**RESPONSE TO REQUEST FOR FURTHER INFORMATION  
PROPOSED REDEVELOPMENT OF BRISBANE WATER LEGACY SENIORS VILLAGE  
51-57 & 59 MASONS PARADE, POINT FREDERICK NSW**

### Brisbane Water Legacy - Responses to DPIE Request for Additional Information

### **IDG Architects Response to Referrals and Submissions**

DA-3101 B

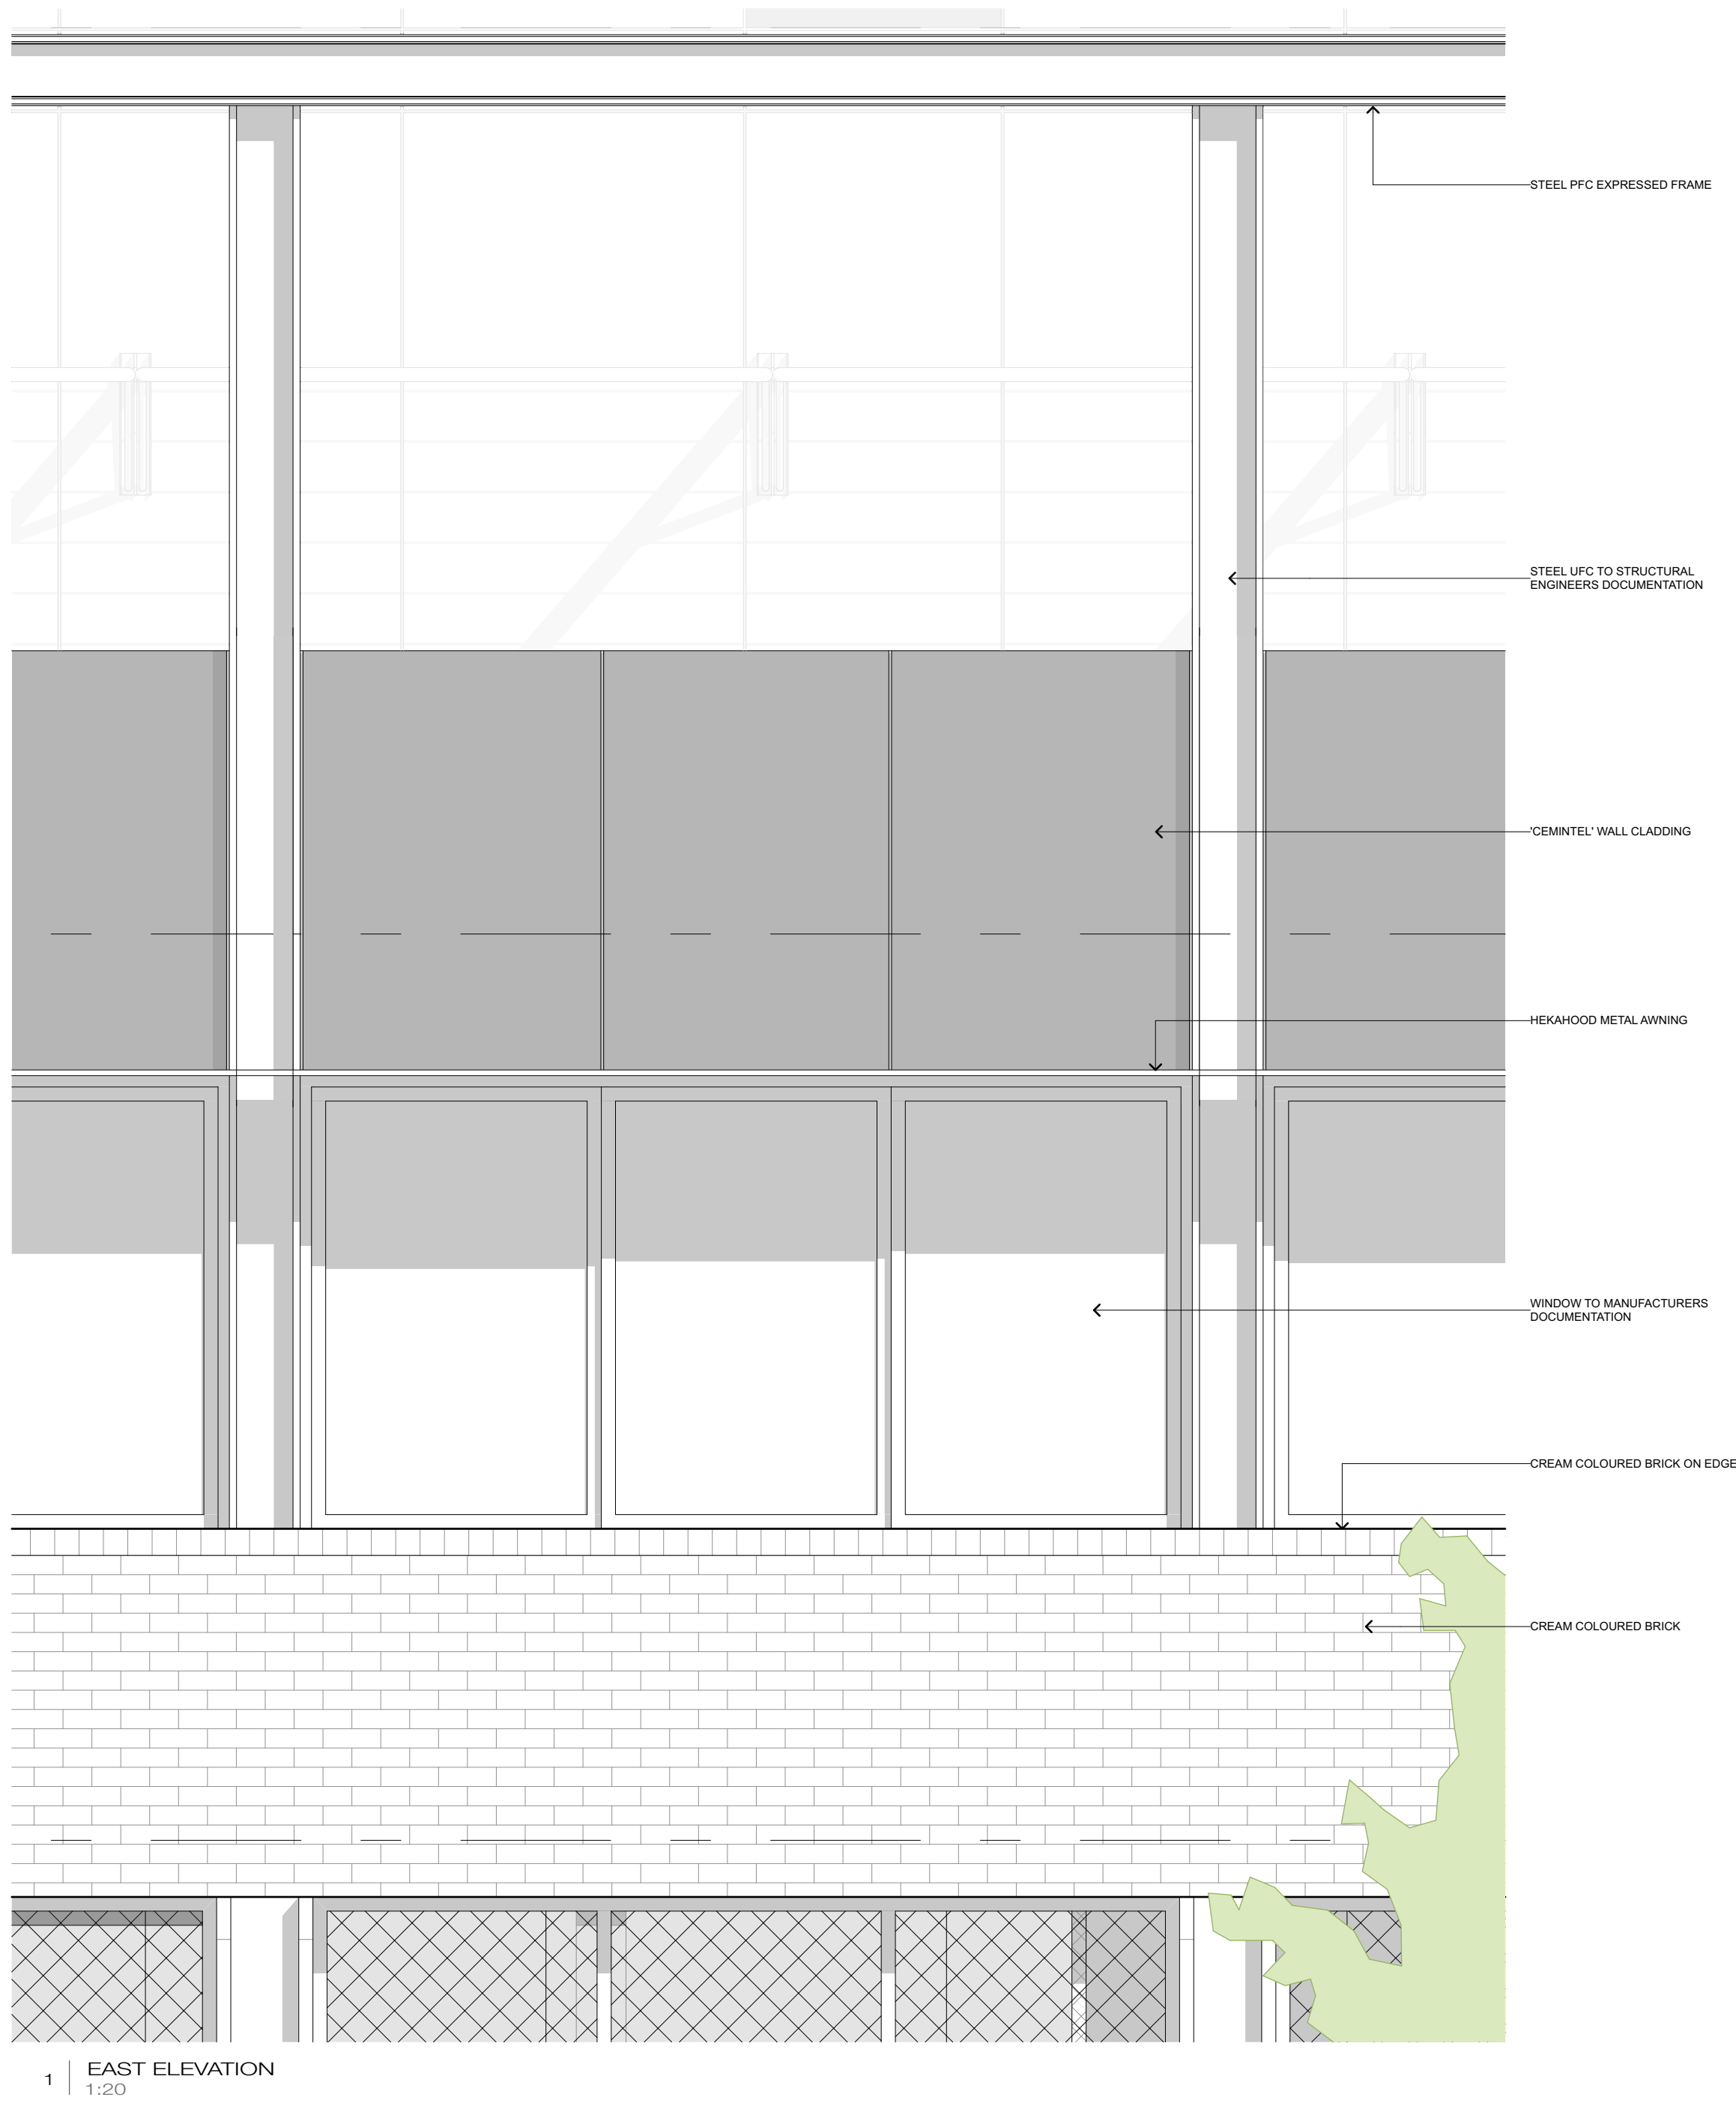
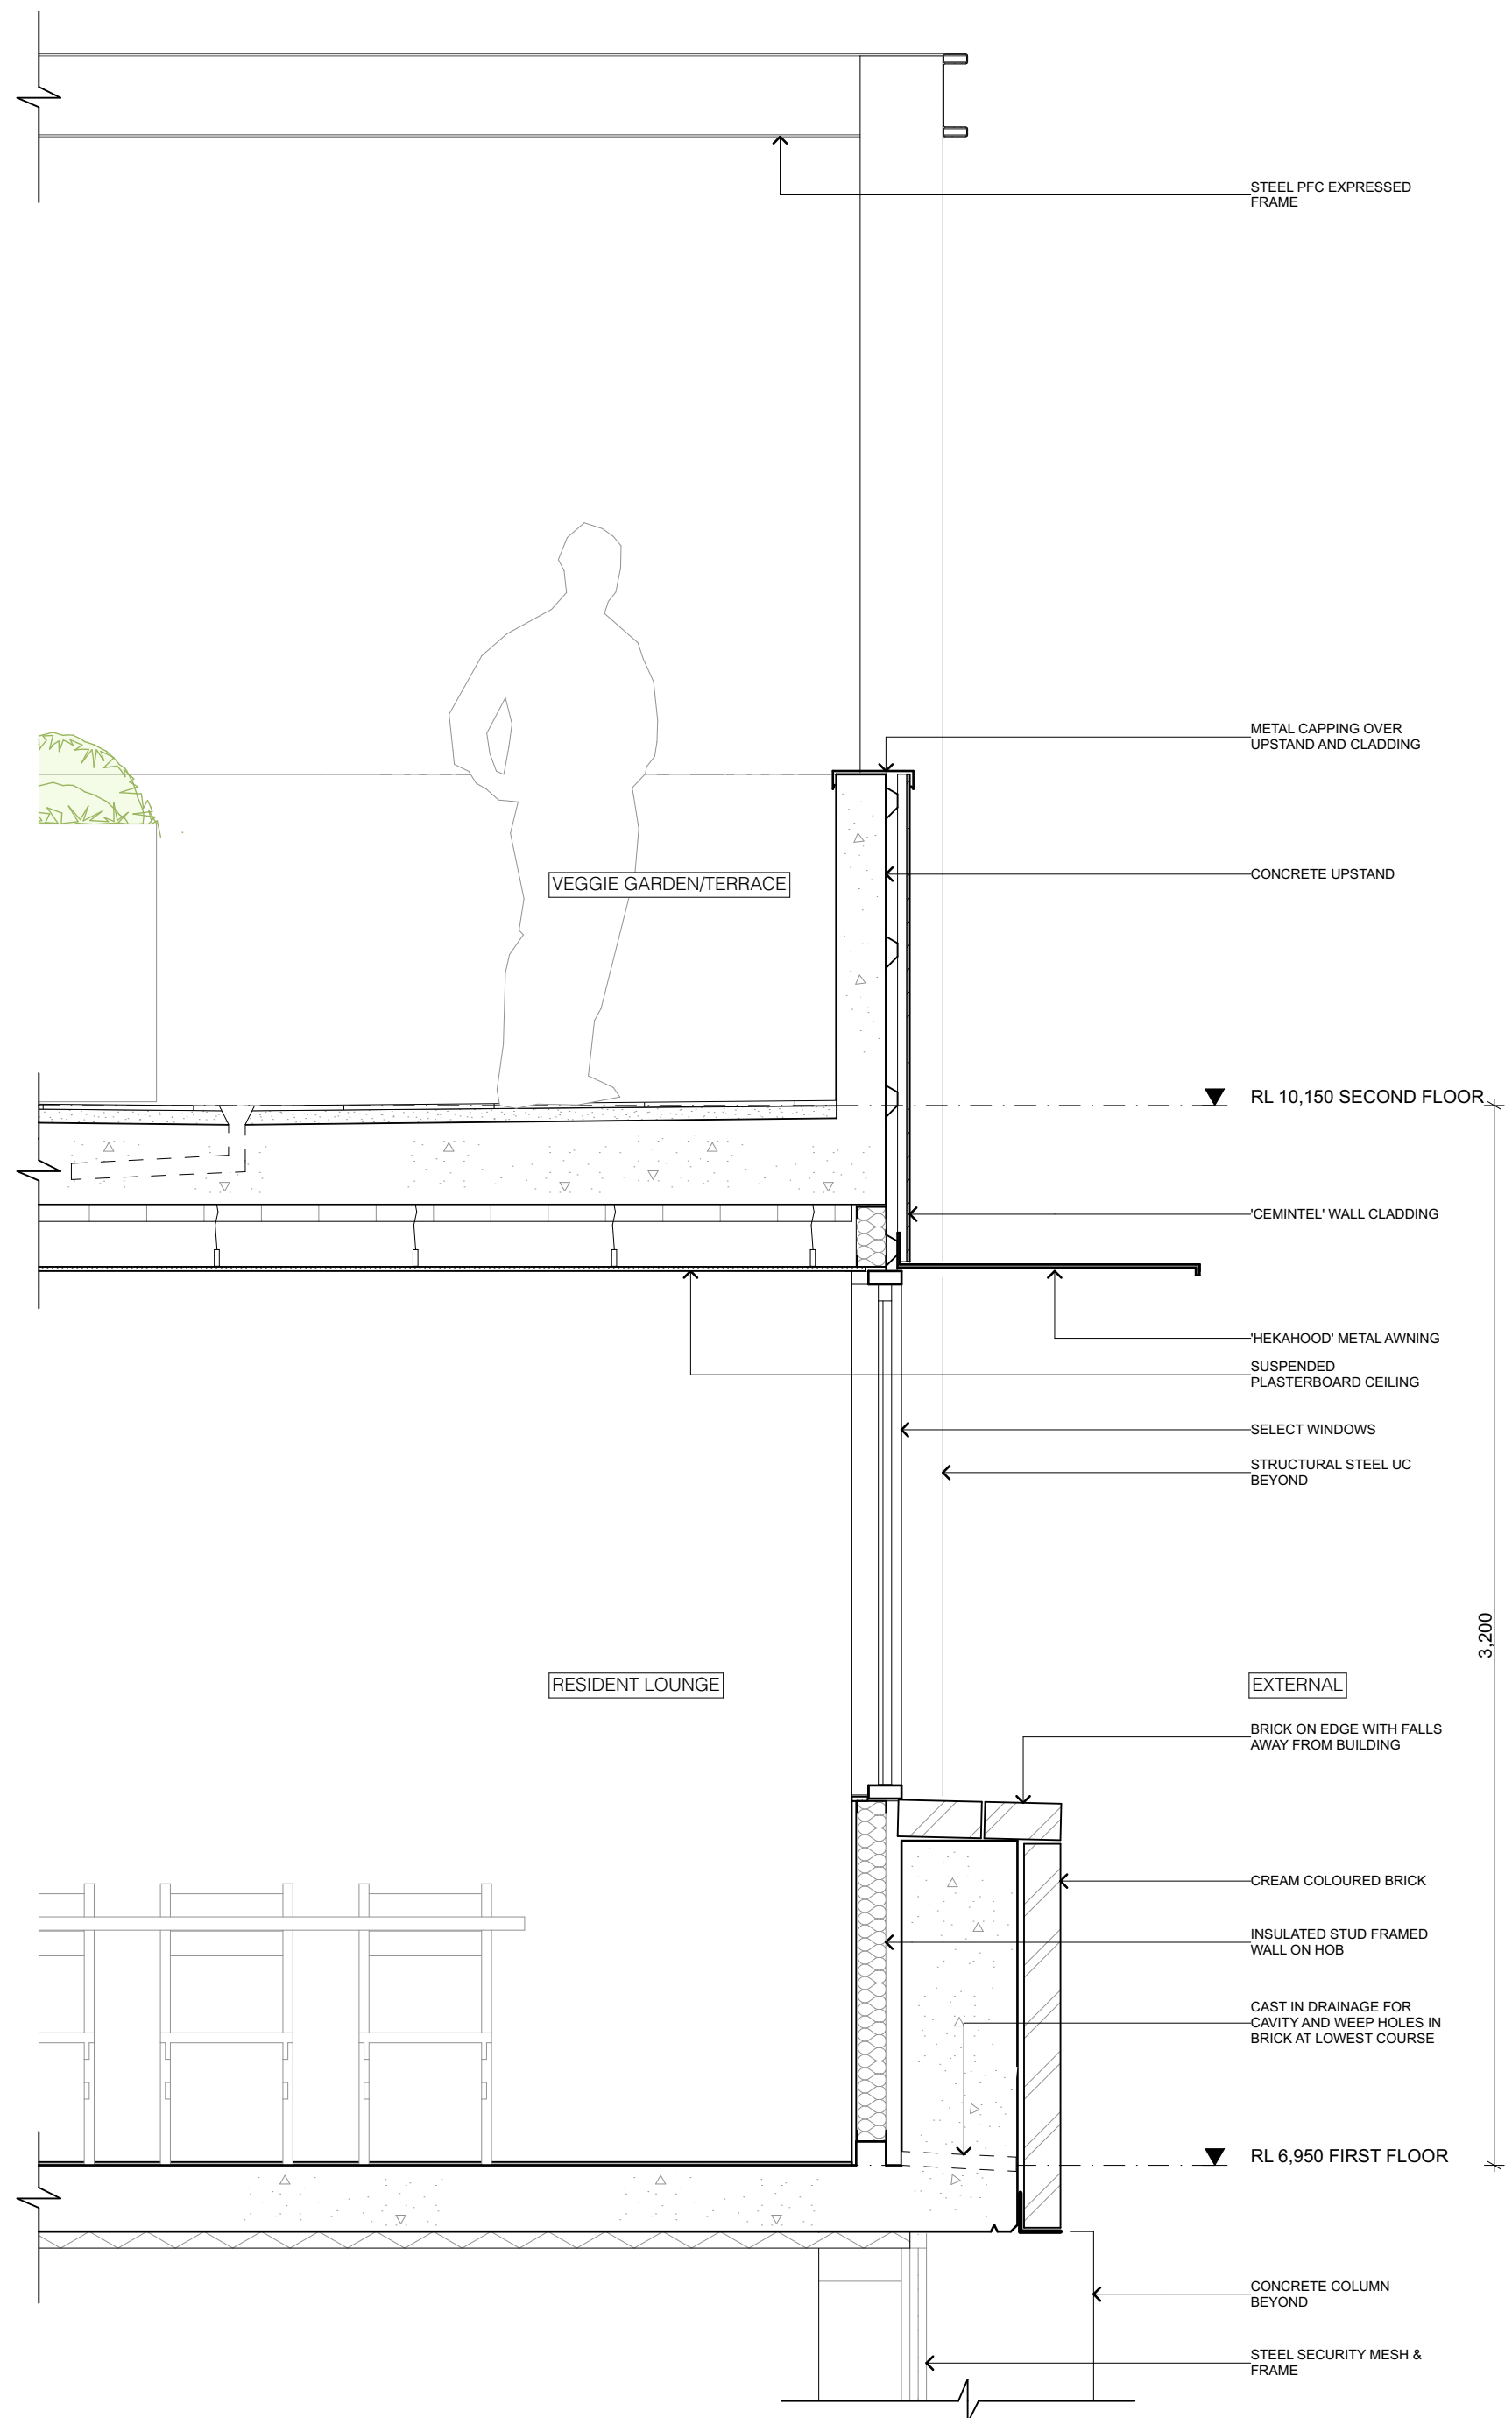
Item	Requested Information	Applicant's Response
	<b>20<sup>th</sup> December 2021 - Regional Assessments</b>	
1	A sun shading resident lounge area is required. Design solutions used in the existing design may be suitable to be used at this location	Refer to drawing DA-3101 Detailed Section a 'hekahood' 900mm wide is proposed - <b>Attachment B</b>
2	Submit detailed sections of the proposed facades to satisfy the State Environmental Planning Policy No 65 – Design Quality of Residential Apartment Development submission requirements under Schedule 2 Forms of the Environmental Planning and Assessment Regulation 2000.	Refer to drawing DA3100, DA-3101 and DA3102 Detailed Sections - <b>Attachment C</b>
3	Submit additional drawings, including elevations, for the maintenance and garbage storage building.	Refer to drawing DA 9400 Maintenance shed - <b>Attachment D</b>
	<b>27<sup>th</sup> January 2022 - Transport for NSW</b>

### **Sun Shading Resident Lounge**
